Staff Summary Report

SUBJECT: Hold a public meeting for a Development Plan Review for COX REELS OFFICE & WAREHOUSE located at 6713 South Clementine Court.

COMMENTS: Request for **COX REELS OFFICE & WAREHOUSE (PL070548)** (Don Cox, D.C. Leasing, Inc., owner; Bob Winton, Winton Architects, Inc., applicant) consists of a single story warehouse and office building of approximately 34,485 s.f. on +/- 2.05 net acres located at 6713 South Clementine Court in the GID, General Industrial District. The request includes the following:

DPR08010 – Development Plan Review including site plan, building elevations, and landscape plan.

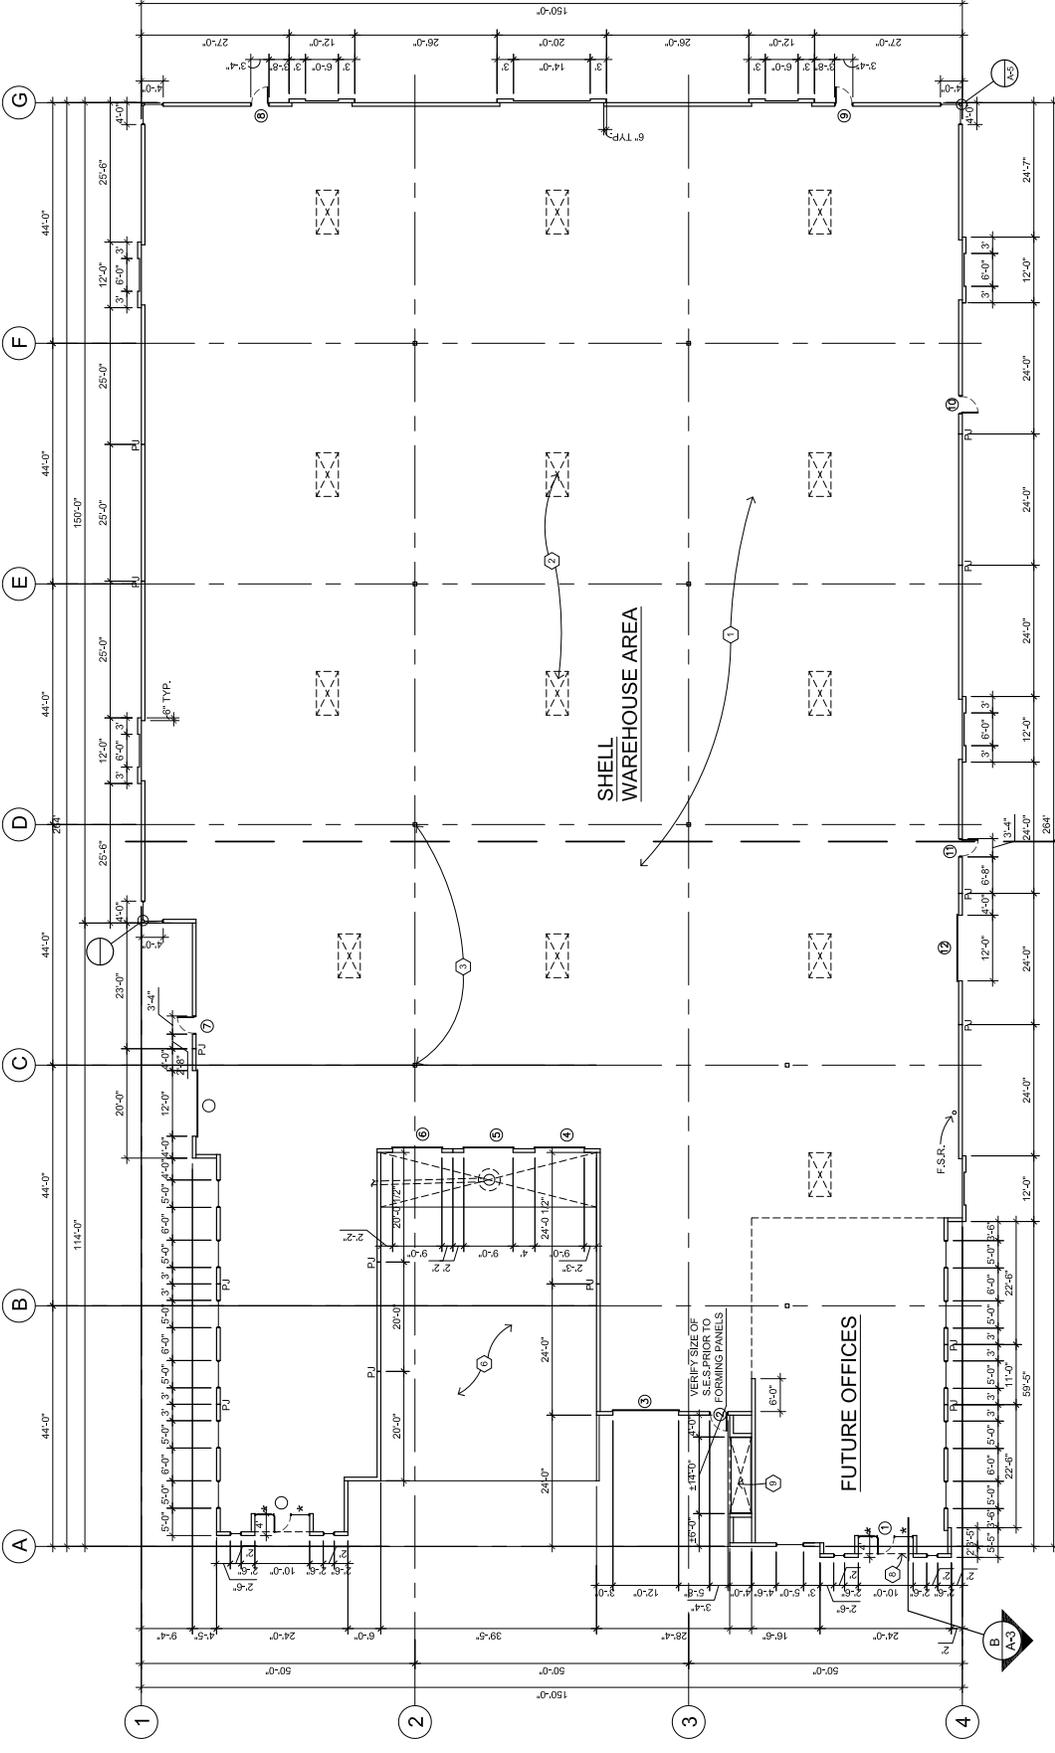
2. Do not disturb existing perimeter walls at the electrical substation to the north and east of the property. It is not necessary to disturb the existing perimeter wall along the west edge of the property. If any of these walls are disturbed or removed, secure permission of adjacent property owner and replace wall with a minimum 8'-0" high masonry wall.

3. Demolish existing fence block perimeter walls on Carmen and Priest frontages. Replace these with minimum 8'-0" high, minimum 8" (nominal) thickness concrete masonry unit walls. Steps in top of walls are allowed to follow topographic changes along the length of the wall to maintain the minimum 8'-0" height. Construct perimeter walls of center score exposed 8x8x16 concrete masonry units, where the 8x8x8 grid faces outward toward Carmen and Priest. Paint all exposed wall surfaces either to match the "Cast Pebble" color of the building or provide a color that is complimentary to the building and to the adjacent development to the south. Razor wire or barbed wire is not allowed on top of these walls.

4. Shift the refuse enclosure in the parking row north of the building to align with the "tee" of the turnaround and facilitate trash truck use of the turnaround with a minimum of back-up maneuvering. Provide landscape islands on either side of enclosure. Contact Ron Lopinski of the Solid Waste Division (480-350-8132 or ron_lopinski@tempe.gov) for placement approval.

5. Finish transformer box, electrical and other utility equipment in a neutral color (subject to utility provider approval) that compliments the color scheme of the building.

FLOOR PLAN
 SCALE: 3/32" = 1'-0"
 * INDICATES TEMPERED GLASS

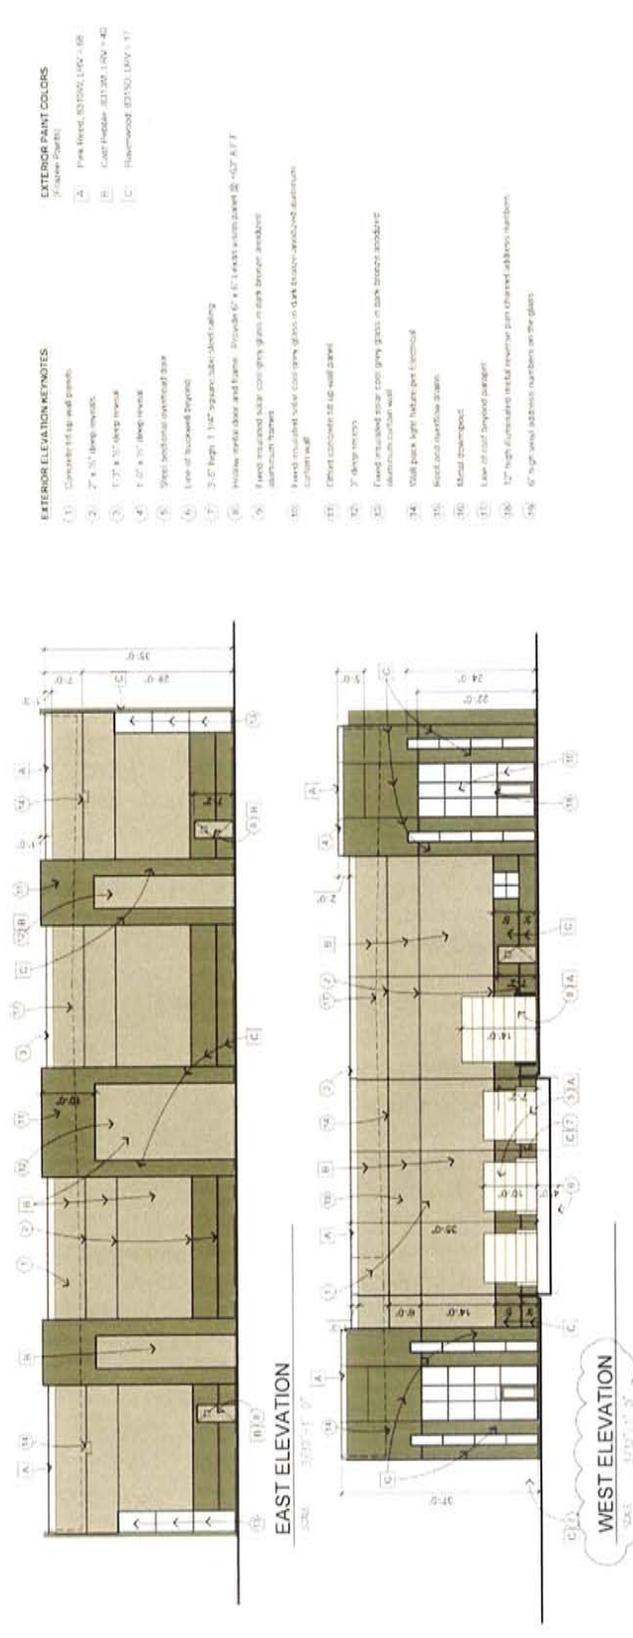
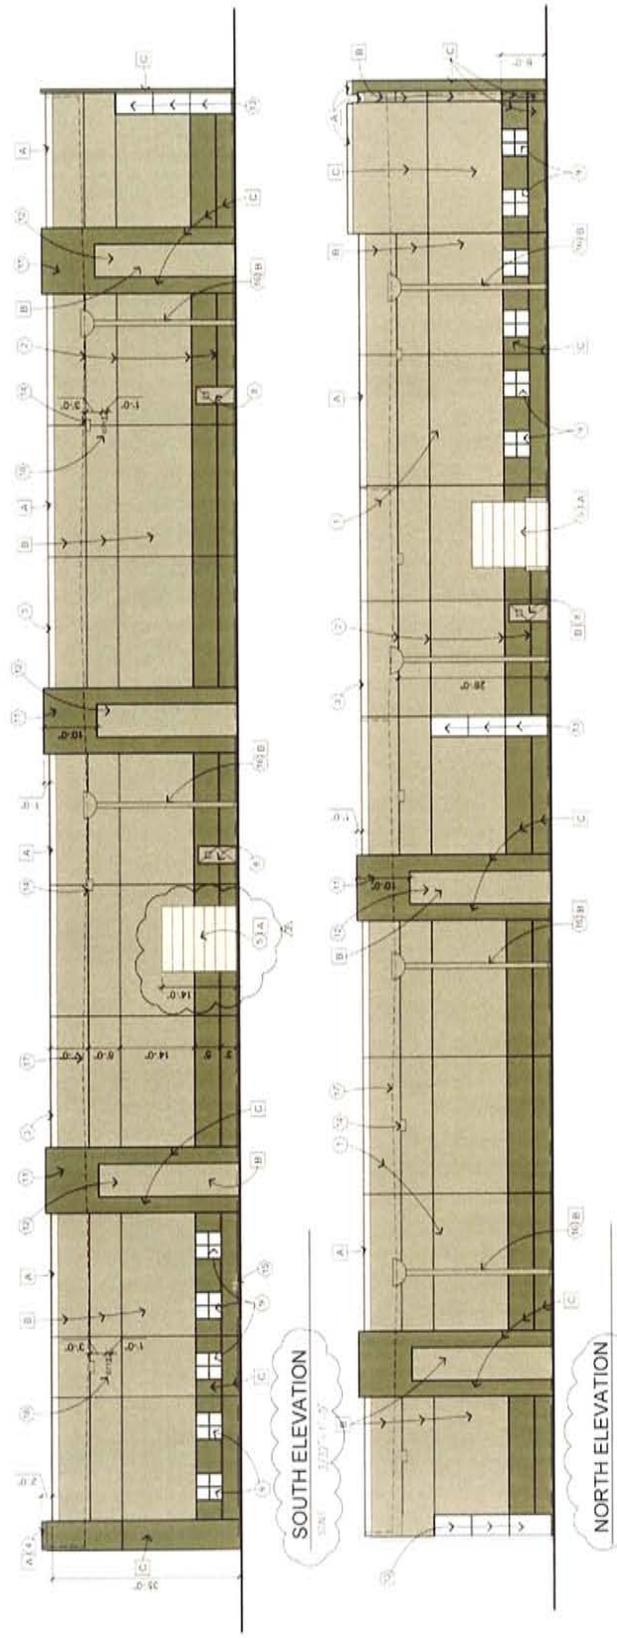
6. Public Restroom Security:
 - a. Lights in restrooms:
 - 1) Provide 50% night lights
 - 2) Activate by key or remote control mechanism
 - b. Single user restroom door hardware: Provide a key bypass on the exterior side.

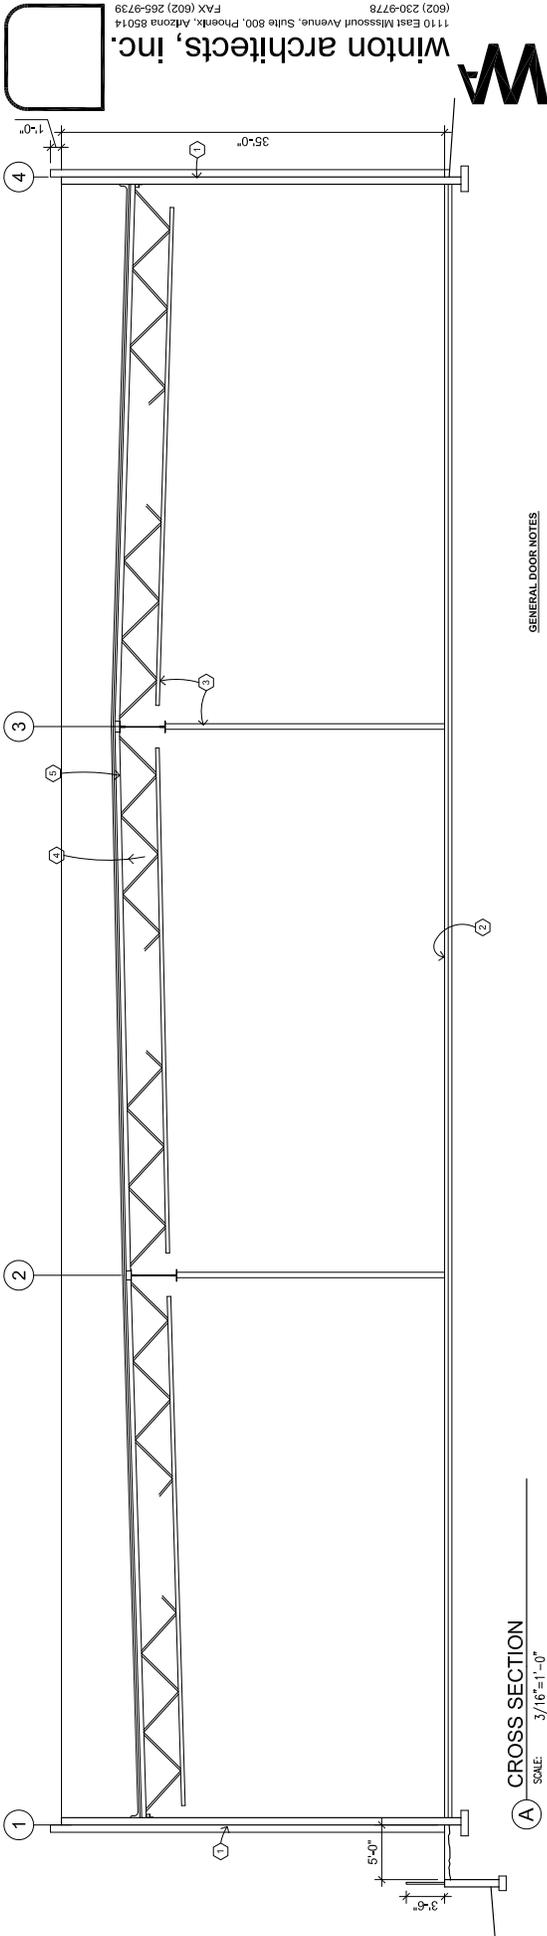
7. Provide complete exterior elevations including those facing the recessed truck well areas not visible on the major elevations. Locate service entrance section on north elevation facing truck yard as indicated.
8. The colors included with the submittal (Pink Reed 8310W, Cast Pebble 8313M, and Ravenwood 8315D) are part of the approval. Indicate the color, type and reflectivity of glass used in the storefront system. Color selection subject to approval by planning staff during building plan check process.
9. Provide secure roof access from the interior of the building. Do not expose roof access to public view.
10. Exposed roof overflows and downspouts as indicated on the south and north elevations and painted "Cast Pebble" for the entire height are acceptable in the positions, quantity and color indicated on the elevations. Provide concrete splash blocks at drain outlets.

11. Incorporate lighting, address signs, incidental equipment attachments (alarm klaxons, security cameras, etc.) where exposed into the architectural design of the building elevations. Building mount lighting or C.C.T.V. is not allowed above top of parapet. Exposed conduit, piping, etc. is not allowed on the exterior elevations unless a creative conduit surface design that compliments the architecture is separately reviewed and approved by the Development Review Commission.
